Device TC29x
Marking/Step ES-BC, BC
Package see Data Sheet

10218AEERA

This Errata Sheet describes the deviations from the current user documentation.

Figure 3 Message RAM Configurations

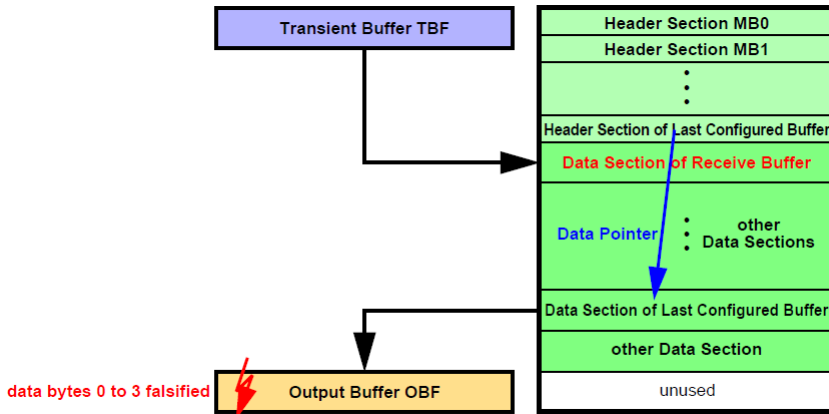
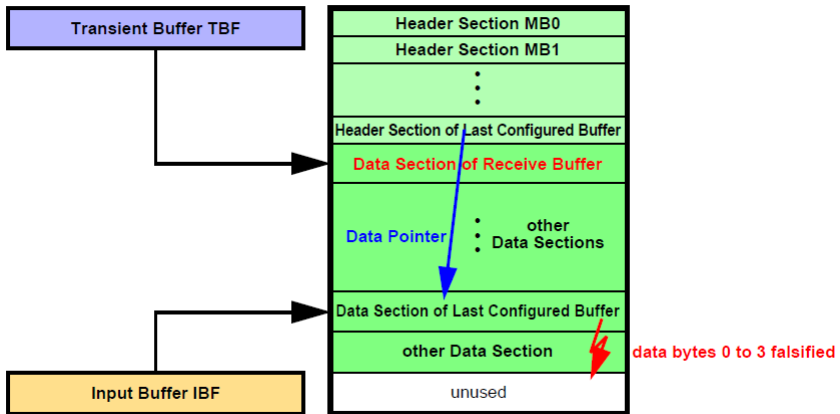
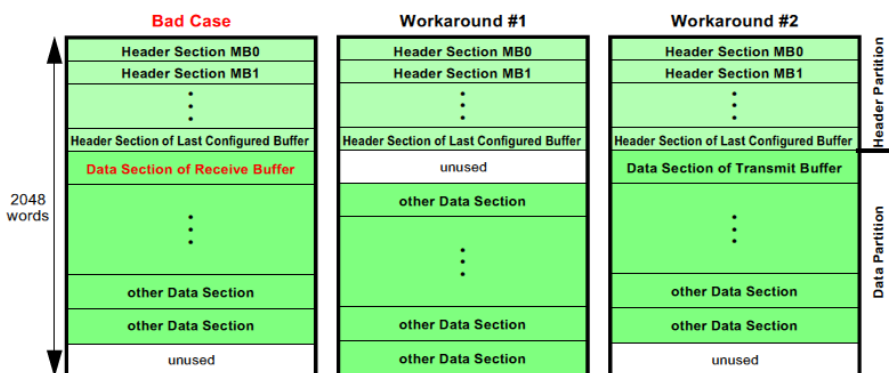
- a) When a message is transferred from the Last Configured Buffer in the Message RAM to the OBF and **PLC** = 127 it may happen, that at the end of the transfer the OBF word on address 00h (payload data bytes 0 to 3) is overwritten with unexpected data (see [Figure 1](#)).
- b) When a message is transferred from IBF to the Last Configured Buffer in the Message RAM, it may happen, that at the end of the transfer of the Data Section one additional write access overwrites the following word, which may be the first word of another message's Data Section in the Message RAM (see [Figure 2](#)).

2) Ensure that the Data Section directly following the Header Partition is assigned to a transmit buffer.

Figure 13 SENT Tolerance of this Design Step

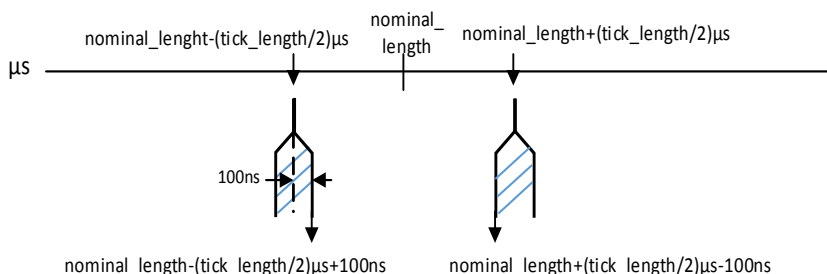
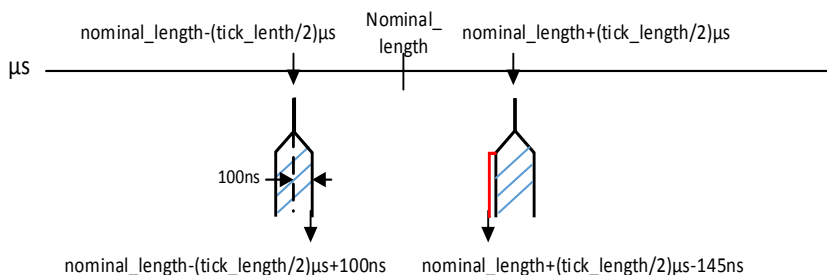
In this design step the range is delimited as follows:

- The lower border is $\text{nominal_value} - (\text{tick_length}/2) \mu\text{s} + 100 \text{ ns}$
- The upper border is $\text{nominal_value} + (\text{tick_length}/2) \mu\text{s} - 145 \text{ ns}$.

Figure 14 Short Serial Message, Serial Data Encoding over 16

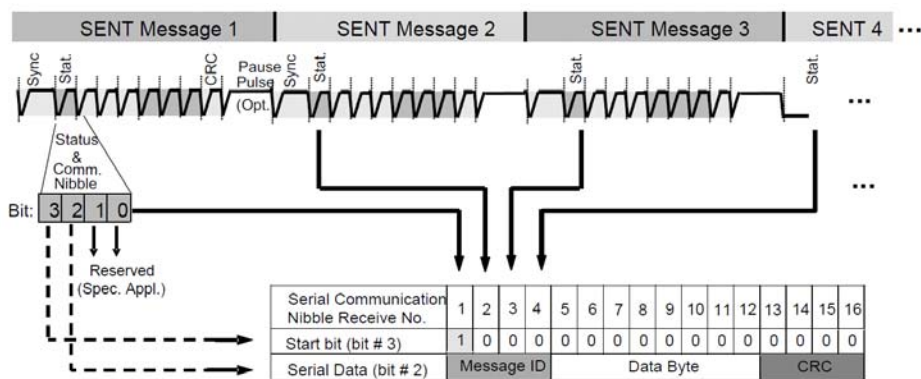
In Figure “Short Serial Message, Serial Data Encoding over 16 messages” of the SENT chapter, the arrows originating from bits 2 and 3 of the Status & Comm Nibble are routed incorrectly and must be swapped.

Figure 14 shows a corrected version of this figure.
